JSP21-51 STATION FLATS

PLANNING REVIEW

Revised Concept Plan and Request to Amend Consent Judgment

DRAWING NUMBER:
L-1.0

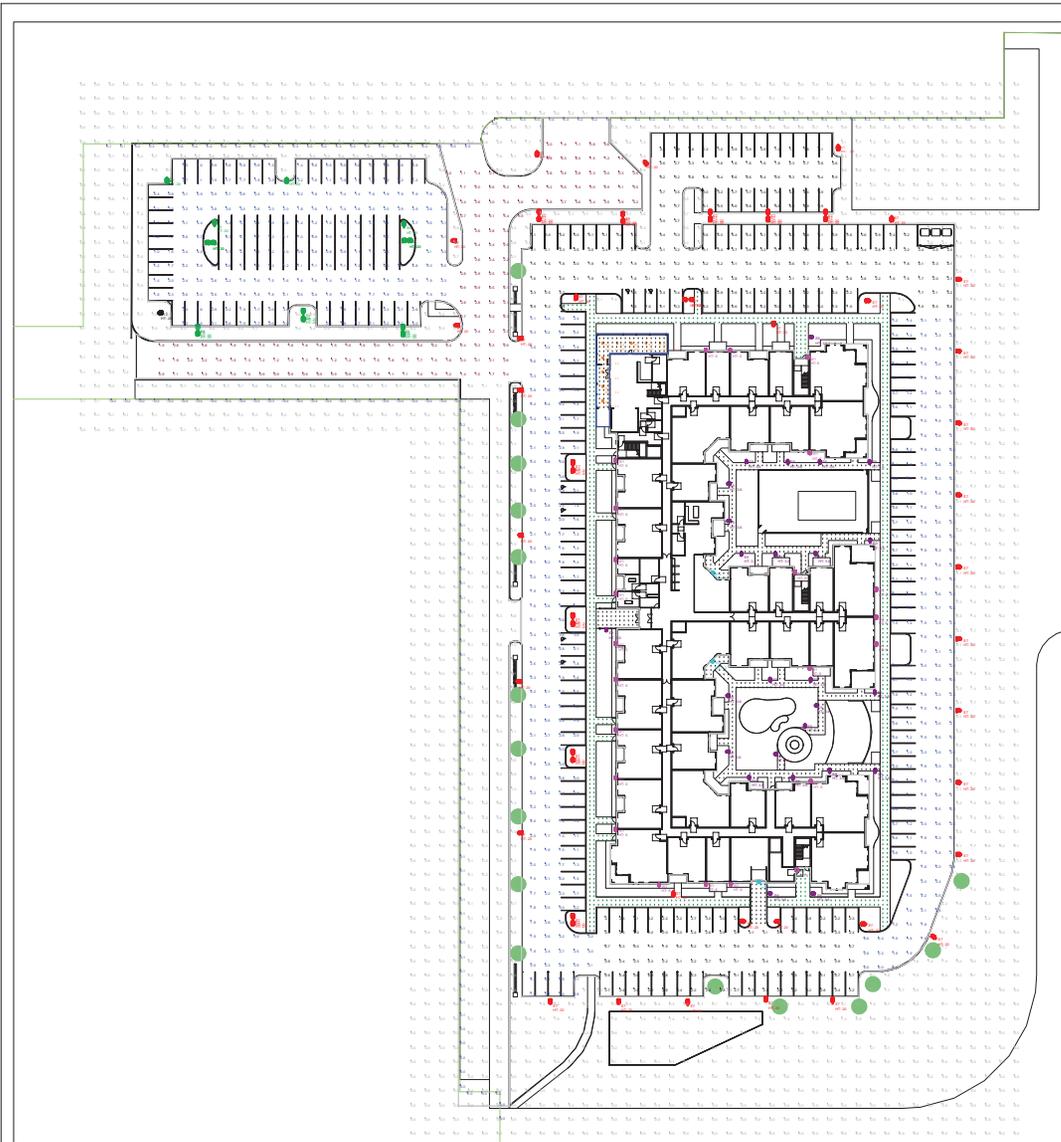
Item	Required	Proposed	Meets Code	Comments
				<u>replacements and the proposed plan which shows 5 being preserved, 33 replacements must be added to the plan. They can be planted in the existing conservation easement if desired.</u>
Soil type (LDM 10)	As determined by Soils survey of Oakland county	Sheet L-1.0	Yes	
Zoning (LDM 10)	<ul style="list-style-type: none"> • Site: I-1 • Proposed: RM-1 with PRO • North, East, South, West: I-1 (Commercial use) 	Sheet L-1.0	Yes	
PROPOSED IMPROVEMENTS (LDM 10)				
Existing and proposed improvements	Existing and proposed buildings, easements, parking spaces, vehicular use areas, and R.O.W	<ul style="list-style-type: none"> • Yes • Dimensions provided on Sheets C-3.0-C3.2 	Yes	
Existing and proposed utilities	<ul style="list-style-type: none"> • Overhead and underground utilities, including hydrants • Proposed light posts 	<ul style="list-style-type: none"> • Proposed utilities are shown on the Utility Plan and Landscape Plans • No light posts are shown on the landscape plan. 	<ul style="list-style-type: none"> • Yes • No 	Please add all proposed light fixtures to the landscape plan and resolve light/tree conflicts.

PLAN VIEW: NOT TO SCALE

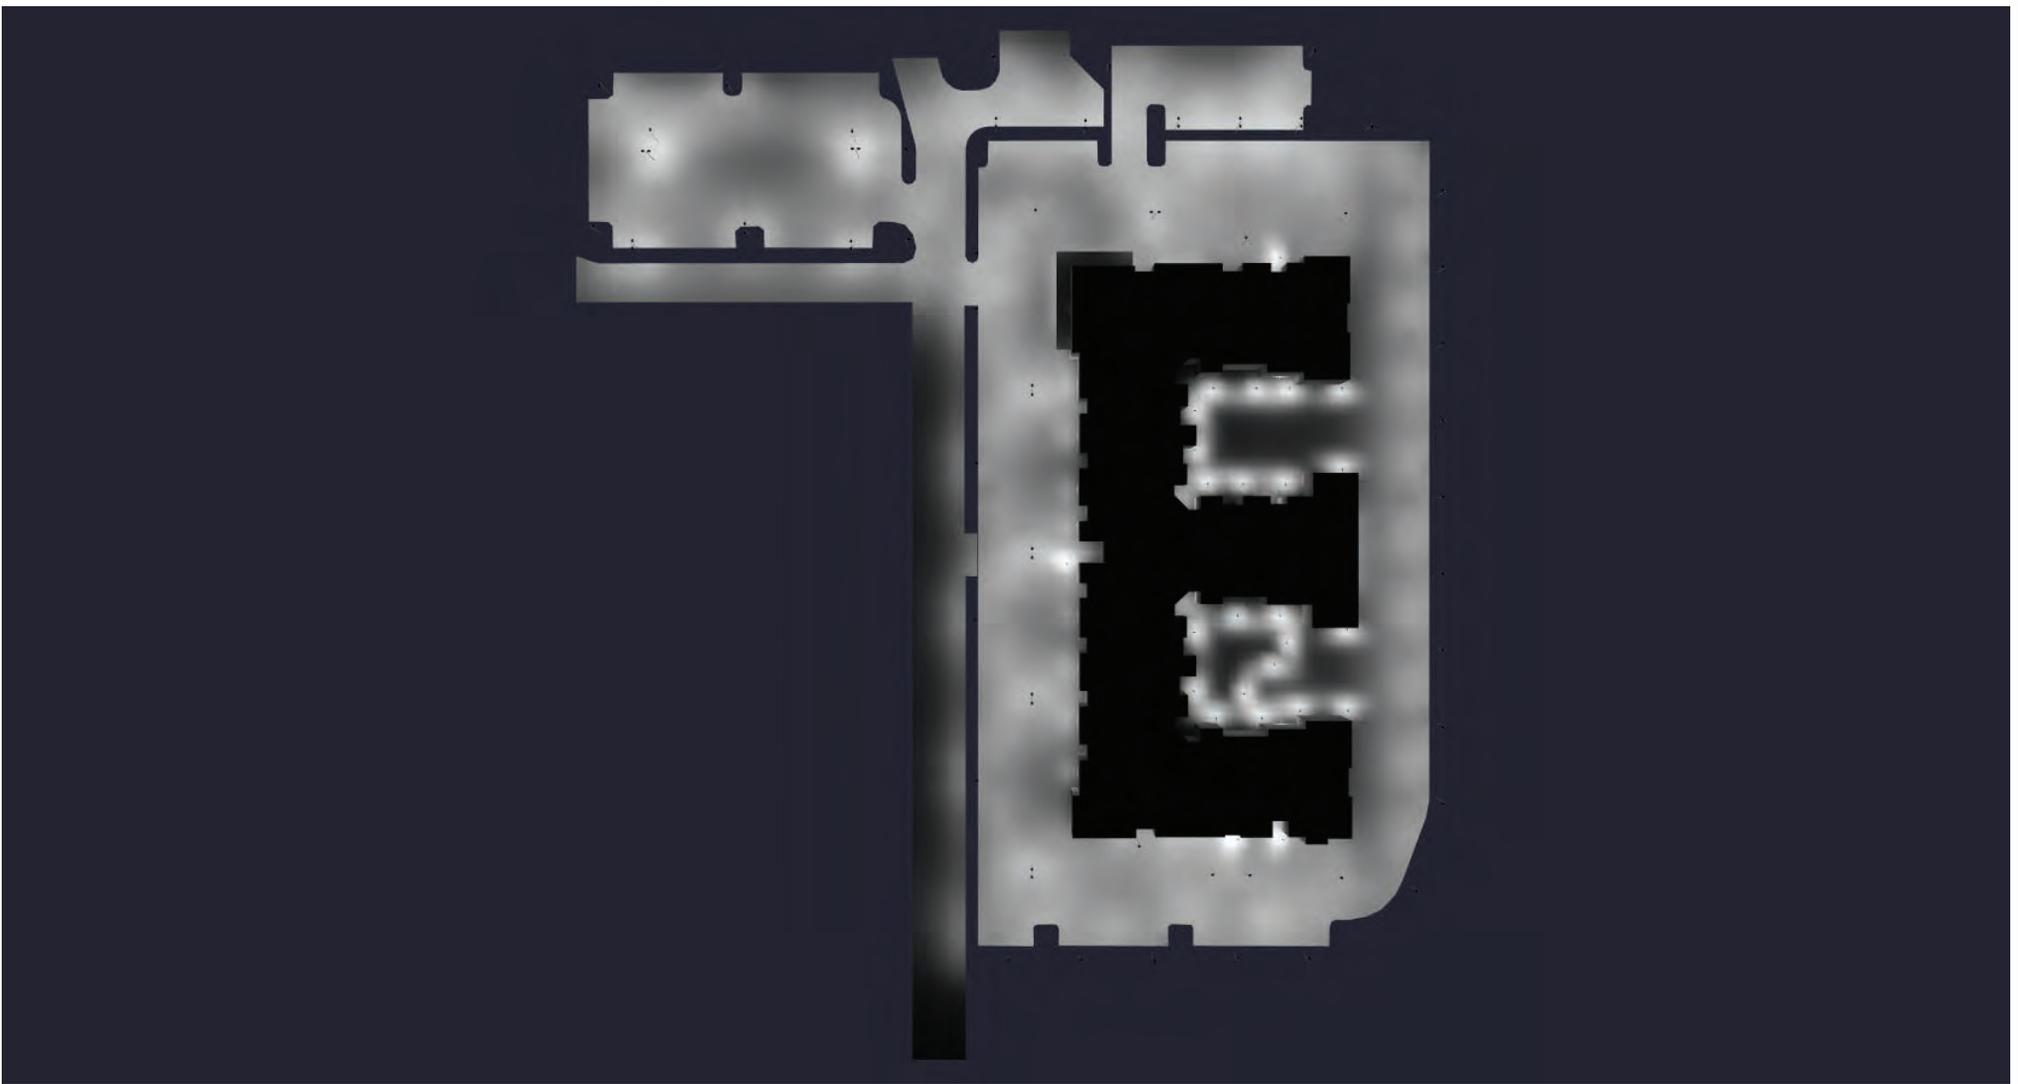
9. Lighting & Photometric Plan (Sec. 5.7): There are several items that should be addressed on the photometric plan with the next submittal as listed below.

- a. Lighting Specifications (Sec. 5.7.A.2.ii): **Please provide specification sheets for the proposed light fixtures, fixture mounting detail, fixture design, and fixture hours of operation.**

- b. Minimum Illumination (Sec. 5.7.3.K): **Please revise the main entrances to buildings to meet the 1 fc minimum (0.8 fc shown).**
